JOINT WITNESS STATEMENT (JWS) IN RELATION TO:

Topic: Ayrburn Screen Hub – FTAA-2508-1093

Date: 16 January 2026

Supplementary Landscape Assessment Memo

Figure 1. Masterplan with Ayrburn Structure Plan Overlaid

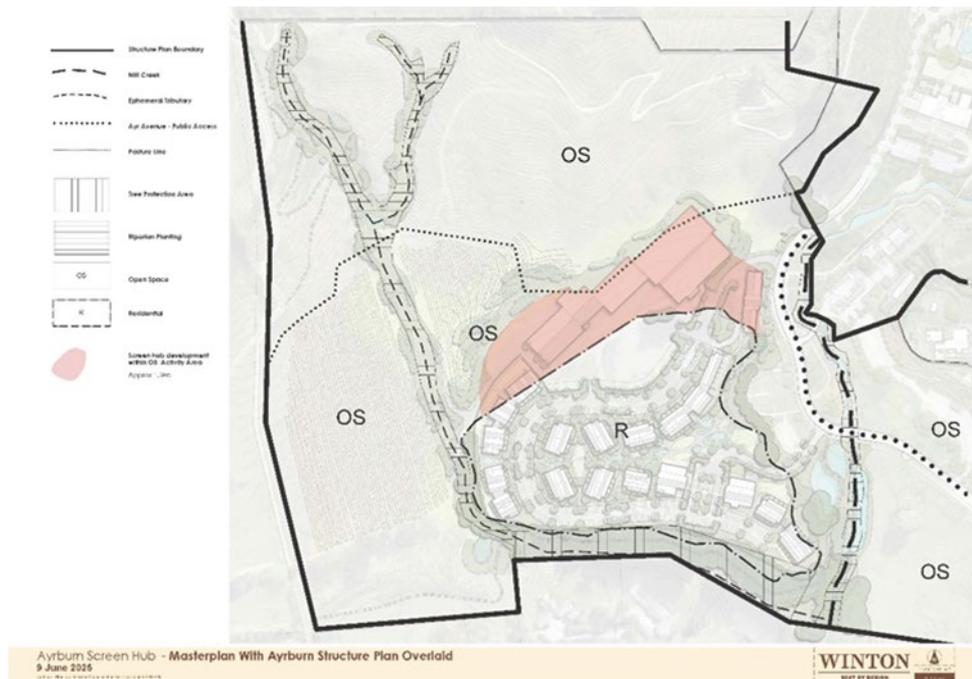
When one ‘steps back’⁵ and considers the continuous spatial patterning of the land to both the east and west, I acknowledge that there will be a relatively small loss of spaciousness, openness and ruralness, but cannot see how such a small (in terms of area) intrusion into the OS will adversely affect these sensory elements, and the ‘spatial approach articulated in the District Plan, both at a landscape unit and Ayrburn Structure Plan scale’, to the extent claimed by Ms Gilbert.

It is my understanding that the OS area as shown on the ASP is intended to provide an appropriate interface between development in the ASP and adjacent zones - particularly the Millbrook Resort Zone (MRZ) and the Waterfall Park Zone (WPZ). In my opinion this is retained in a meaningful way and does not erode the deliberate approach as per the PDP provisions.

Furthermore, I find the proposal is consistent with the spatial patterning that sees nodes of rural living development interspersed with ‘breathing space’. This is primarily because it is physically and visually contained, is proximate to the WPZ, is part of an evolving Ayrburn character and when viewed from beyond the Site is seen in the context of the adjacent relatively intensive rural residential development and therefore a ‘node’ with the pastoral landscape of Speargrass valley to the east and west.

Figure 2: Figure 1 - Appendix 20 Proposed Contour Overlay Plan (red linework) overlaid on Existing Contours (black linework) from the Landscape Peer Review.

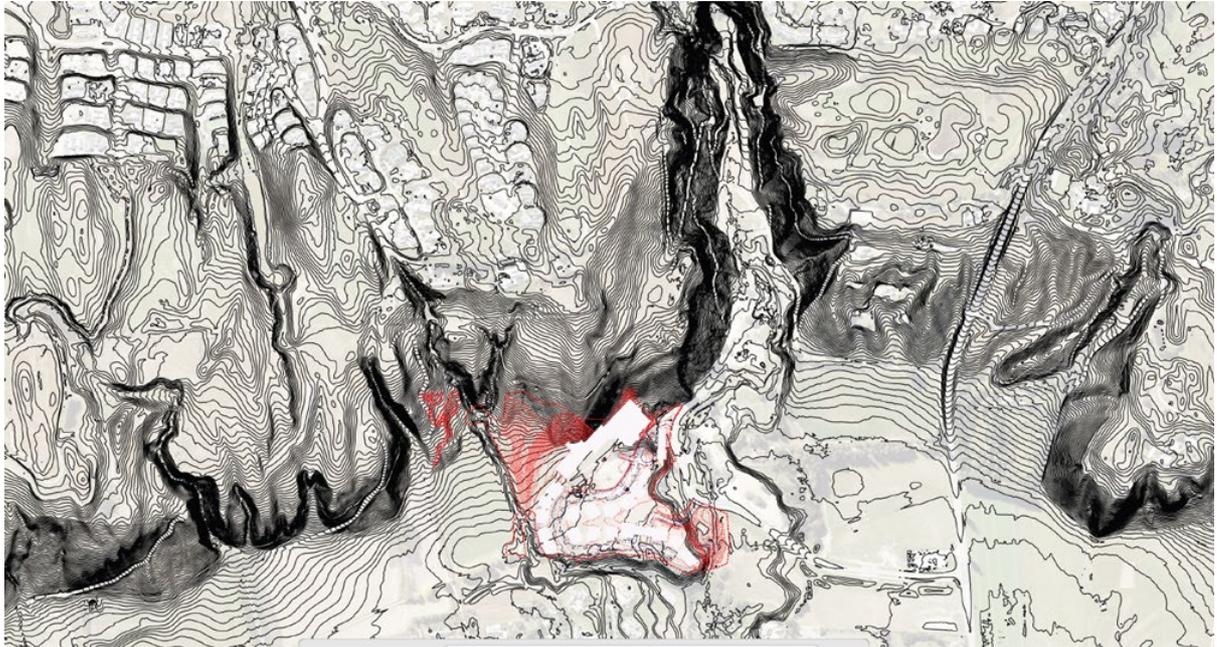
In response to Ms Gilbert's comments at [5.25 – 5.29] regarding the proposed spur, it is my experience through involvement in several infrastructure projects over the years that a bund is often a 'standalone landform' and typically regular (and somewhat sausage like) in both width and height. In my opinion that is quite different to both a mound and a spur extension, as is the case with the proposed landform. Given the fact the proposed landform varies in both width and height across its length, and extends from a sub spur of, and at the toe of Christines Hill it will mimic an extended natural spur landform and will not be incongruous within the wider landscape setting.

In my opinion Figure One (as shown as Figure 2 below) within Ms Gilbert’s report demonstrates the small scale of the spur extension in the context of the continuous sequence of escarpment slopes of the Wharehuanui Hills landform that define the edge of the Speargrass Flats alluvial valley floor.

At the broader Speargrass Flats scale, due to the small and contained scale of the spur extension, the legibility and expressiveness values associated with the Wharehuanui Hills landform are maintained.

Figure 4 – [REDACTED] Viewpoint Locations used for Visual Modelling

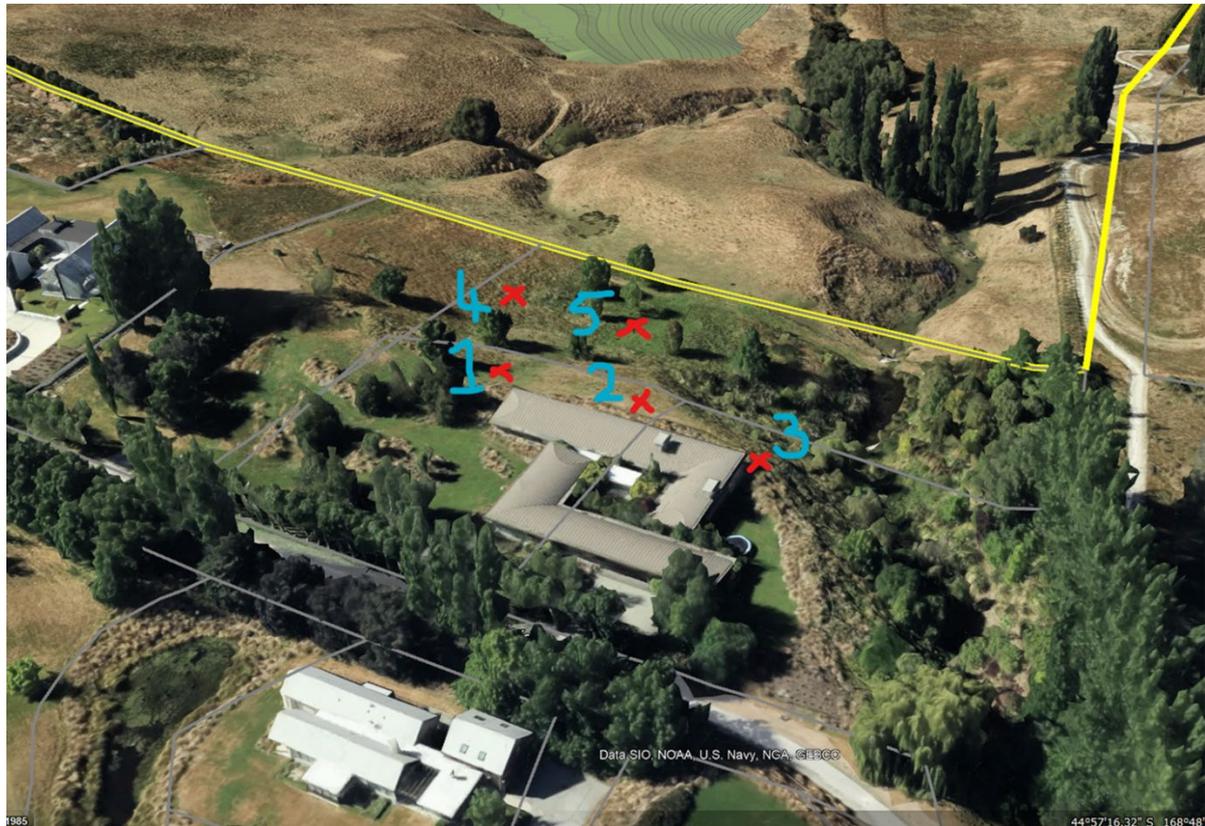
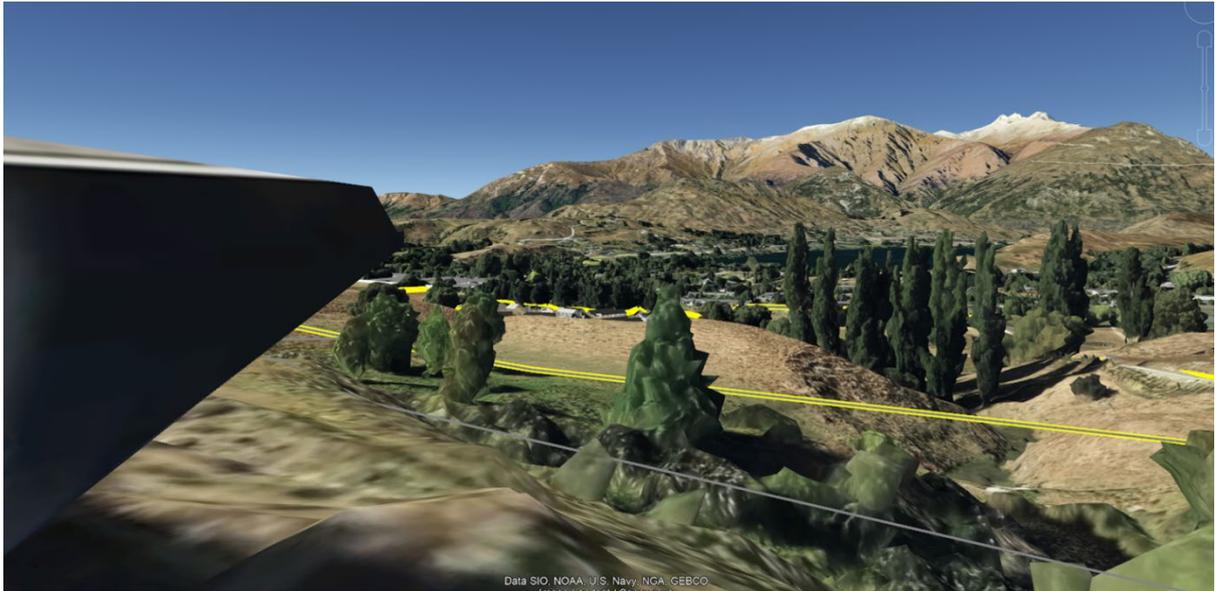
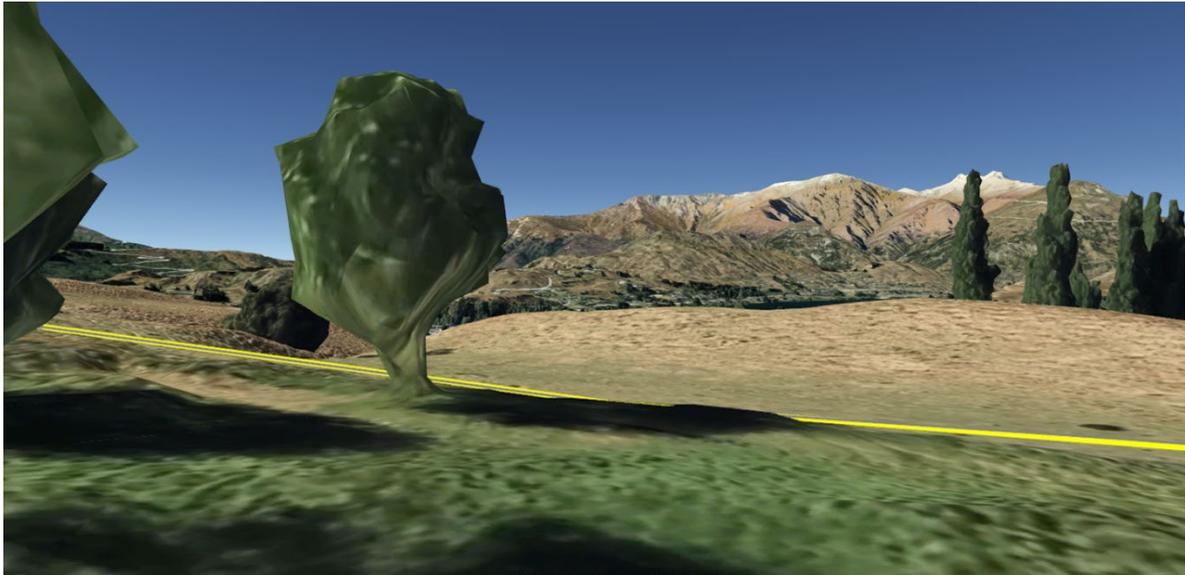
- 8.2 **BG** does not consider that the Google Earth model views provided in **TM**'s Supplementary Report form a reliable basis for effects conclusions in relation to the neighbours' properties.
- 8.3 **TM** considers the model views to be accurate, as these have incorporated the modelling previously prepared for the proposal, to the extent to assist with his comments on effects in relation to the neighbours' properties. **TM** reiterates that in his Supplementary Memo he has also relied on his own familiarity of this boundary interface.
- 8.4 For completeness, **BG** has visited [REDACTED] (in relation to a peer review for a resource consent application on that property) and notes that a reasonable proportion of the screen hub site is visible from that property.

Five views were modelled and overlain in a Google Earth model, see Figures 4 - 9 following that show snips from the modelling. The Google Earth model used includes the proposed spur extension which can be seen in Viewpoints 1 and 4. It does not include any of the planting associated with the proposal.

The double yellow line in the modelling depicts the boundary of the Site, while the yellow coloured 'dashes' identify the accommodation units (which have been modelled) that will initially be visible from the submitter's property. Notably, due to existing landform, the studio buildings will not be visible at all from these Viewpoints (which are representative of views from [REDACTED]). Regarding the accommodation units, as the mitigation planting grows on the proposed spur extension, these will be screened in time.

In my opinion Mr Andersson overstates the visual impact and loss of rural outlook when he claims ...*'In particular, two massive sound stage buildings (studios) are planned in the paddock directly west of my house'...* and...*'From my property, these structures will be clearly visible. Today I see pastoral green fields. In the future I'd be looking at industrial sized buildings'*²¹. Then at [19] Mr Andersson claims...*'I anticipate that the pleasant rural vista I currently enjoy will be fundamentally altered and will feel more like looking over a town or large facility'*²².

Figure 10 – Existing Character Plan – Site and Surrounds

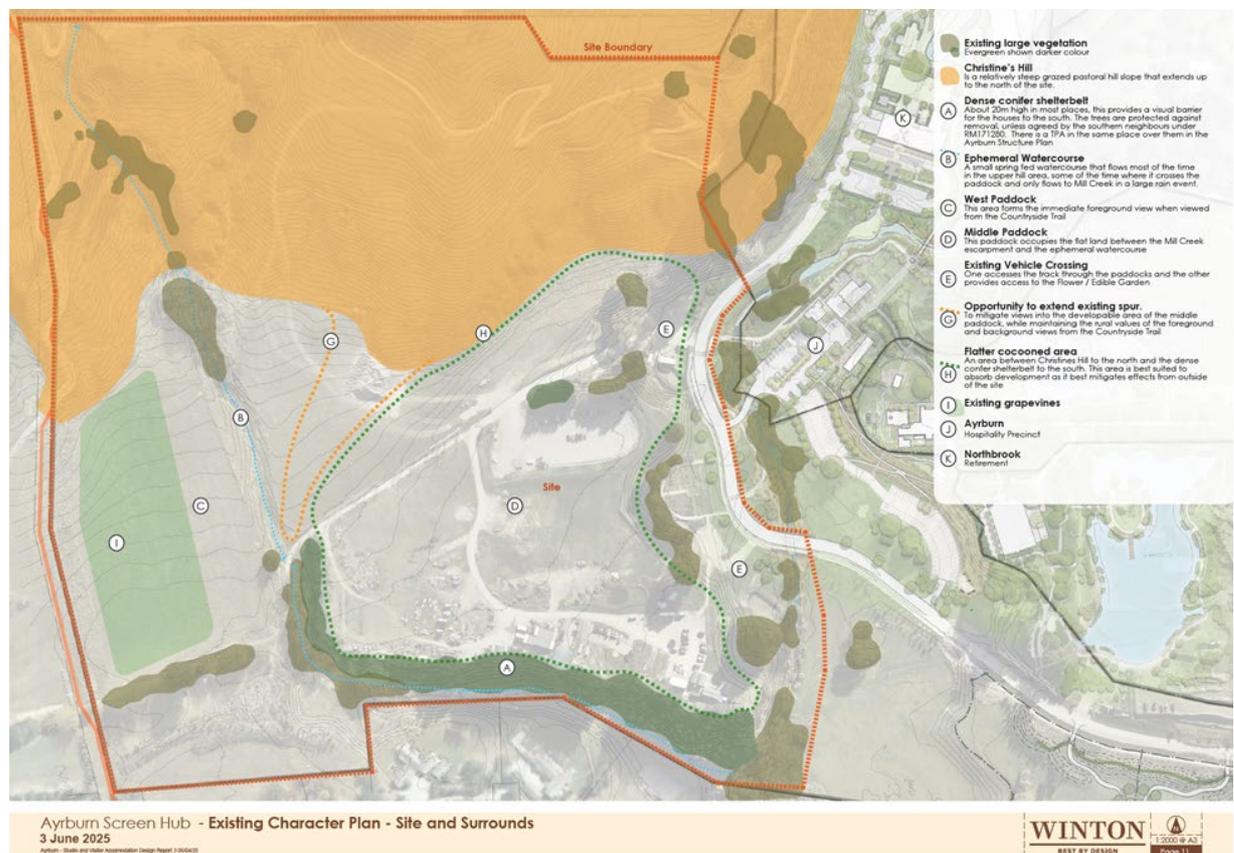
While I have not visited the Collins property at [REDACTED] I have previously walked and photographed the public bike and walking track along this southern edge of Ayrburn and adjacent to the Collins property. In this regard I make the following comments. The conifer shelterbelt identified as 'A' in Figure 10 below, is protected against removal, unless agreed by the southern neighbours under RM171280.

There is also a Tree Protection Area (TPA) in the same place over them in the ASP. In places the conifers are approximately 25m in height, and where there are gaps (as shown in the Collins' photographs) additional conifers have been planted over the last 12 months. While these conifers form a visual barrier and will increasingly do so when the recently planted ones grow, the overall amenity provided by them is relatively poor. The reason for this is threefold. In places they appear unkept, they cast considerable shade and they prevent longer views to the mountainous backdrop.
